RE: Colowyo Coal Company L.P.
Permit No. C-1981-019
Technical Revision No. 158 (TR-158)
Adequacy Response

Revision Description: **TR-158 Prospect Pond Watershed Revision**

Appendix Exh. 7-14PP Prospect Pond

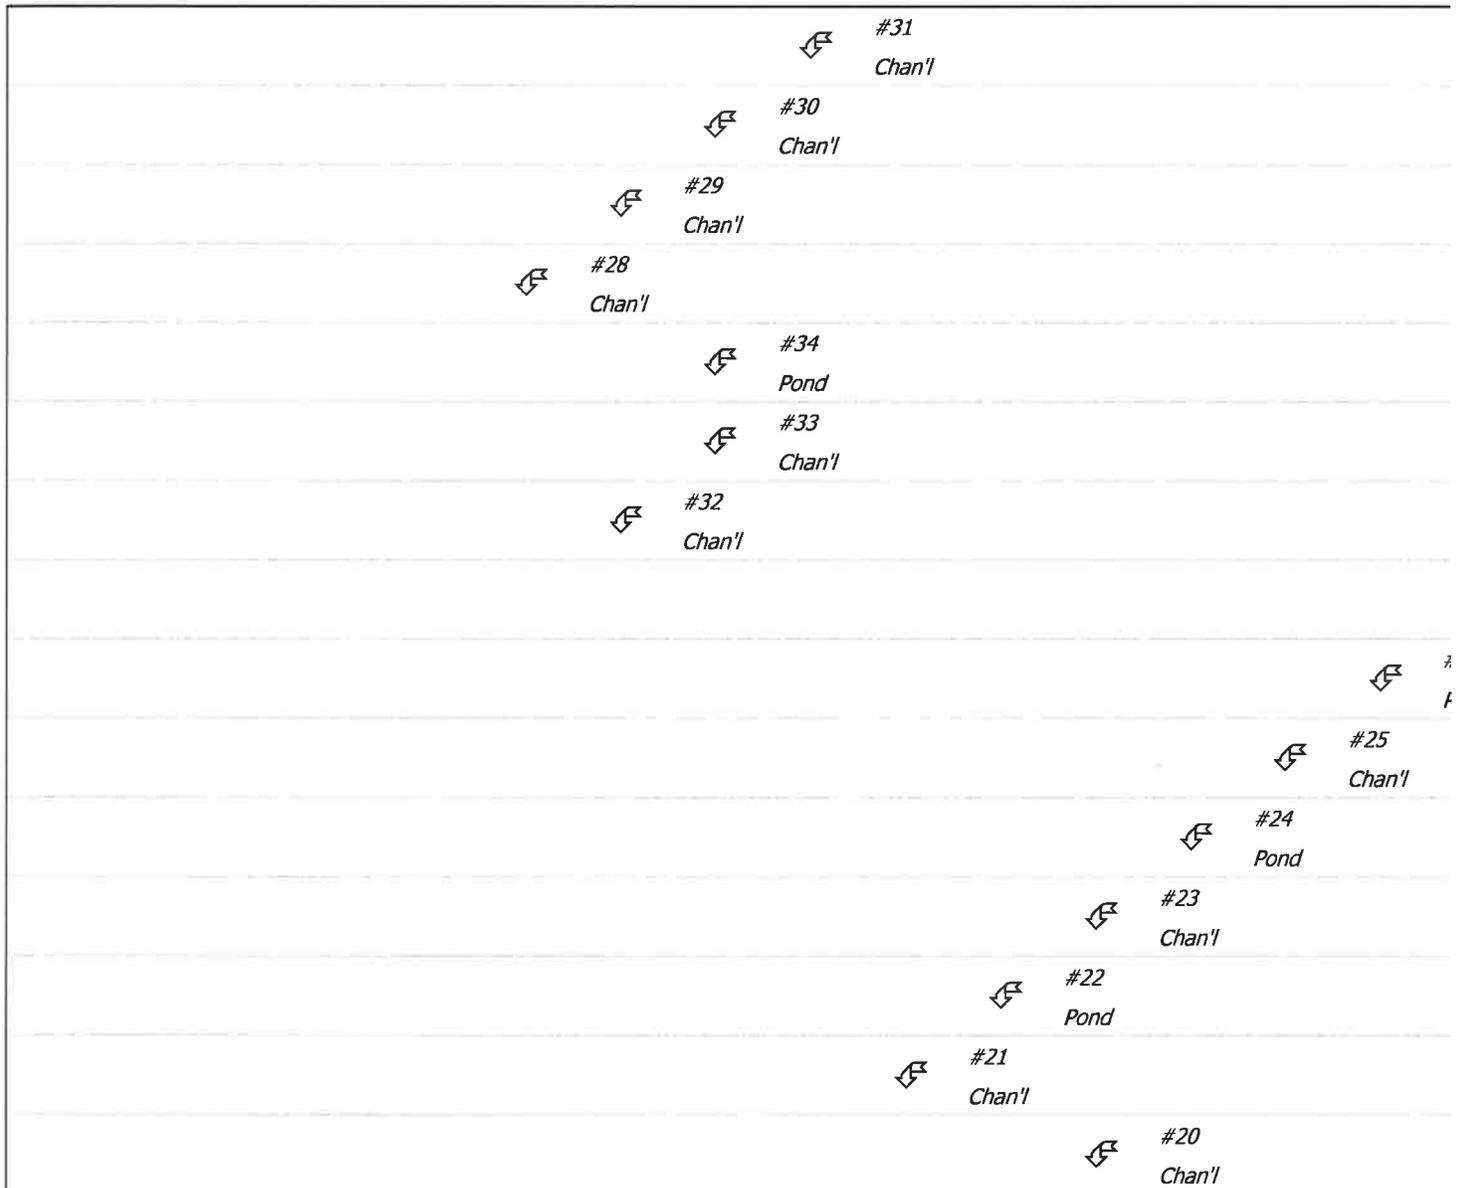
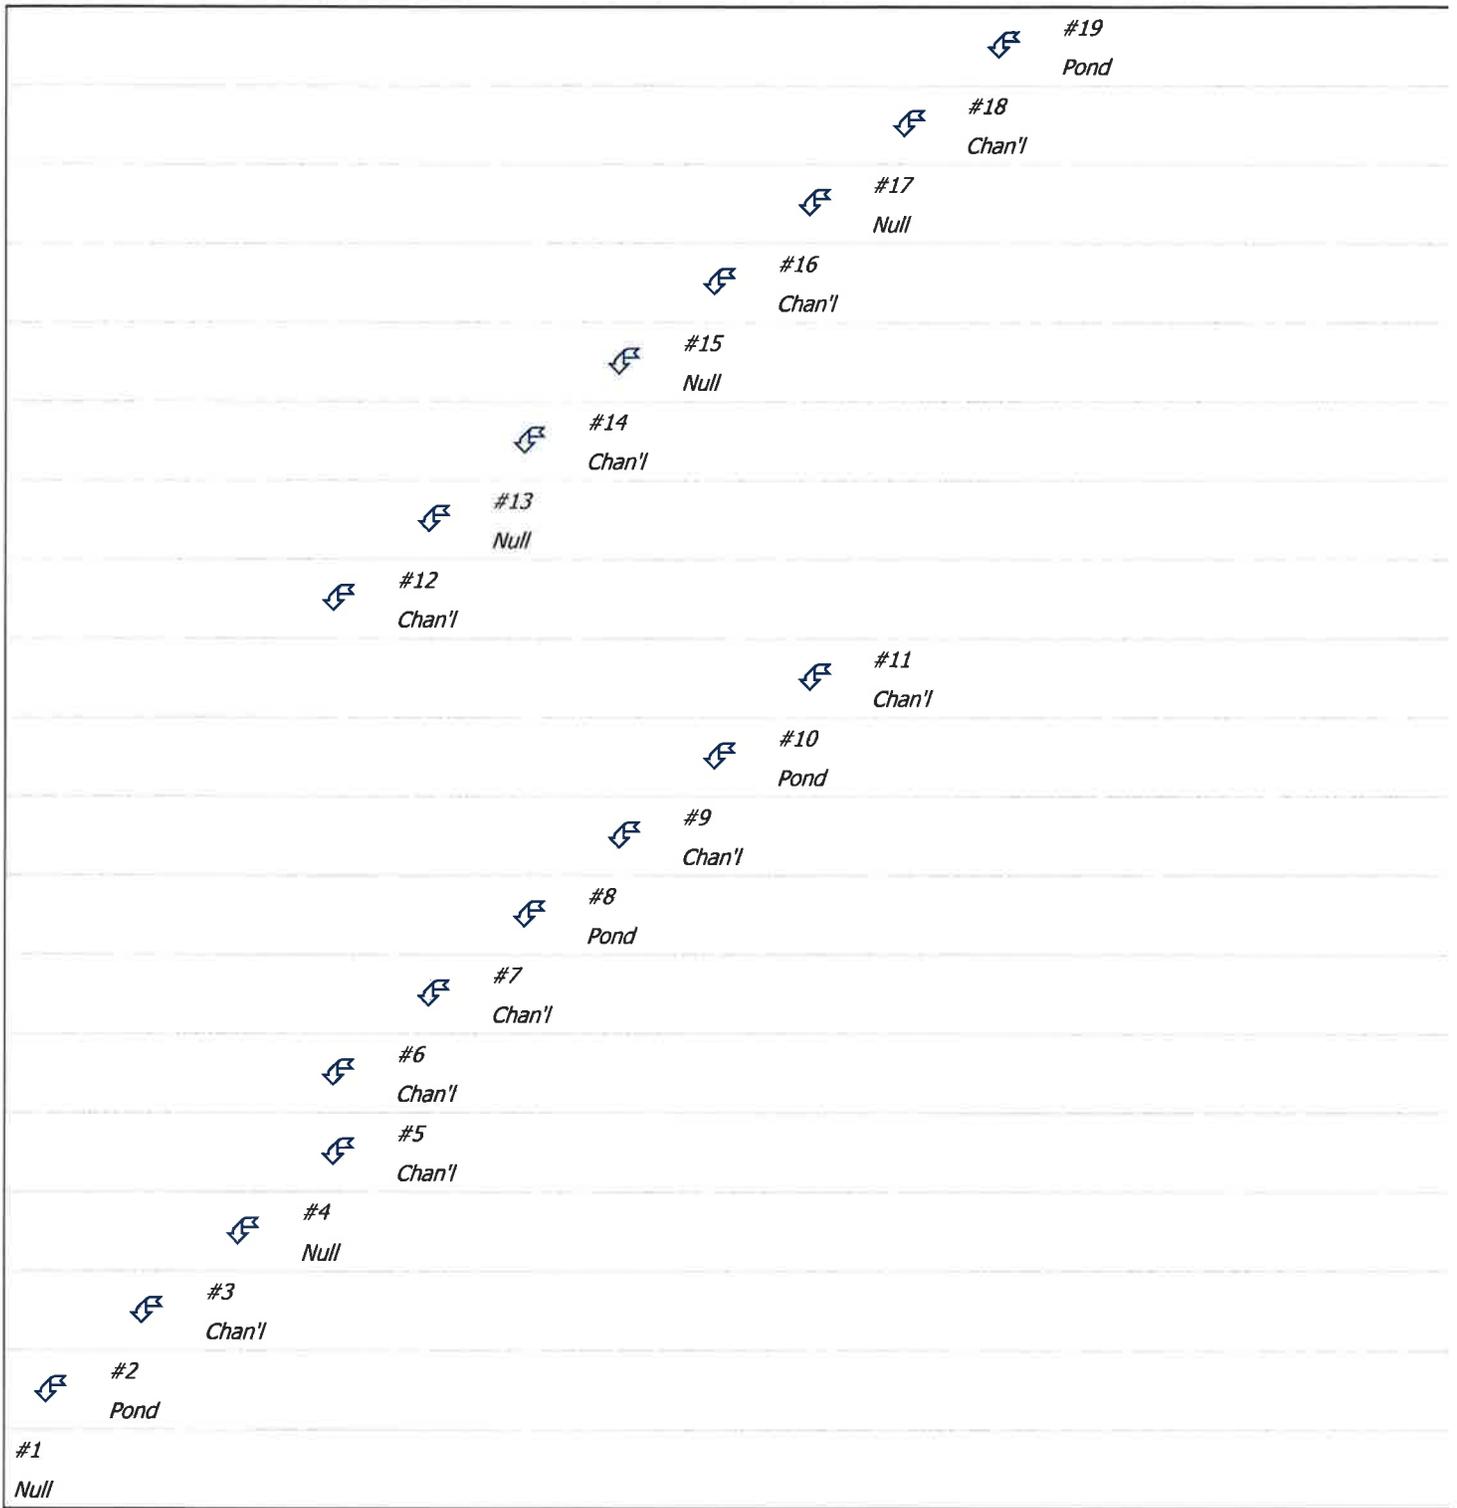
8. *When reviewing the Structure Networking, Structure #24 (EP1) reports to Structure #14 and by-passes Reach 1 of the Final East Pit Ditch. Additionally, there is no Structure assignment for Reach 1 of the Final East Pit Ditch along with the associated Immediate Contributing Acreage. Please provide an updated SedCAD model including Reach 1 of the Final East Pit Ditch and associated Immediate Contributing Acreage with a corrected Structure Networking.*

Response: First, two new Structures (#32 and #33) have been added to the model for the Final East Pit Ditch Reach 1 from the confluence of the Final East Pit Ditch and the North Tributary East Pit Ditch to EP1. Second, to correct the issue with EP1 being routed to Structure #14 only, EP1 is being modeled as two stock ponds. Since EP1 has two emergency spillways, one flows to EP3 and one flowing to Reach 1 of the Final East Pit Ditch (including the straight pipe), EP1 is being modeled as two ponds with a duplication of the capacity of the pond being routed to Structure #32 (Final East Pit Ditch Reach 1) and Structure #21 (EP3 Inlet Ditch). SEDCAD™ is limited in the routing functionality, so taking the capacity of the pond to each corresponding structure simulates both emergency spillways and the straight pipe all being engaged during the theoretical storm event.
